APPLICATION FOR PERCOLATION TEST

SITE INVESTIGATION REPORT
INDIVIDUAL SEPTIC TANK SYSTEM
WITH SUBSURFACE,
SOIL ABSORPTION,
EFFLUENT DISCHARGE

LOCATION OF LOT Fargo Road, Lot 13, Block E

SOIL INVESTIGATION REPORT

DIAGRAM OF PROPERTY

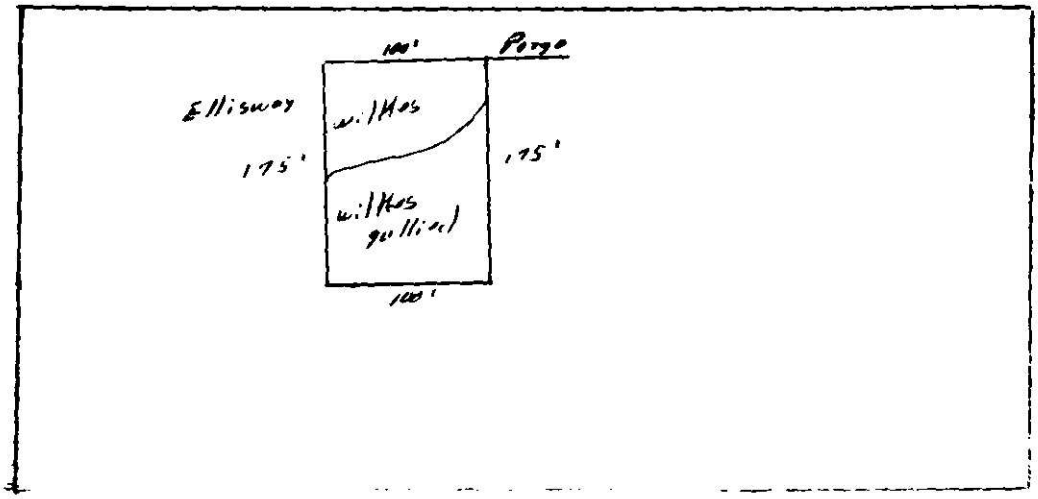
Soil Properties	Soil 1	Soil 2	Soil 3	Soil 4
1. Soil Series	Wilkes	Wilkes gullied		
2. Soil Slope	Suitable 2-8%	unsuitable complex slopes		
3. Soil Depth	unsuitable < 30"	unsuitable < 30"		
4. Soil Texture	unsuitable 2:1 Expanding Clay	unsuitable 2:1 Expanding Clay		
5. Soil Structure	unsuitable Massive	unsuitable Massive		
6. Restrictive Horizons				
7. Soil Drainage	Suitable 76" To Water Table	Suitable 76" To Water Table		
8. Soil Permeability (Percolation Rate)	unsuitable slow > 120 min/in	unsuitable area > 120 min/in		
9. Other *	Less Than 20,000 Sq. Ft 17,540			
10. Overall Rating	unsuitable	unsuitable

Recommendations unsuitable Based on the investigation, the soils on the lot were found to be unsuitable for installation of septic tank systems.
